I am submitting this complaint about the duplex under construction at 1510 NE Fremont Street on behalf of the Land Use & Transportation Committee of the Sabin Community Association. That property is located in the Irvington Historic District. It is also within the boundaries of both the Sabin Community Association and the Irvington Neighborhood Association.

FINAL FINDINGS AND DECISION BY THE LANDMARKS COMMISSION RENDERED ON January 13, 2020

CASE FILE NUMBER: LU 19-207837 HRM
PC # 18-279927
New Duplex in Irvington

2 WINDOW DETAIL
 SCALE: 1-1/2" = 1'-0"

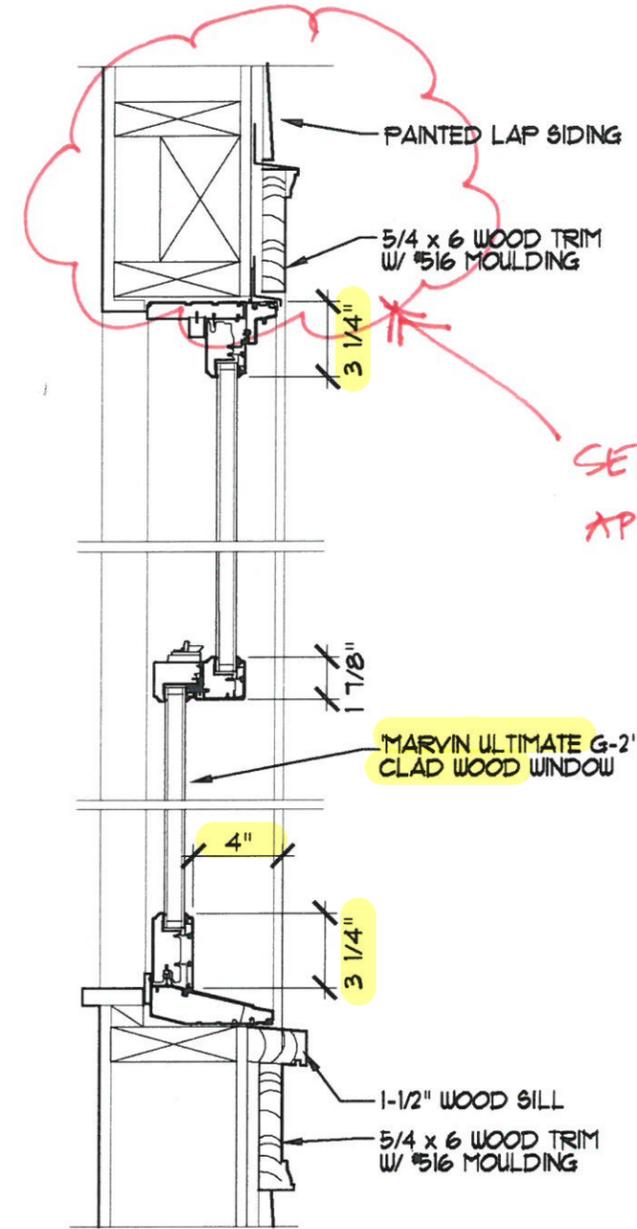
- The windows were required to have 3 ¼ inch tall upper and lower rails. *See Ex. C-3 to the Decision.*
- The lower sashes were required to be recessed 4 inches from the exterior trim. *See Ex. C-3 to the Decision.*

- The windows are not Marvin Ultimate G-2 windows. Instead, they appear to be Milgard windows.
- The windows are not clad wood windows. Instead, they appear to be vinyl windows.
- The window rails do not appear to be 3 ¼ inches tall. Instead, they appear to be approximately 2 inches tall.
- The lower sashes do not appear to be recessed 4 inches from the wood trim. Instead, they appear to be recessed approximately half that distance.
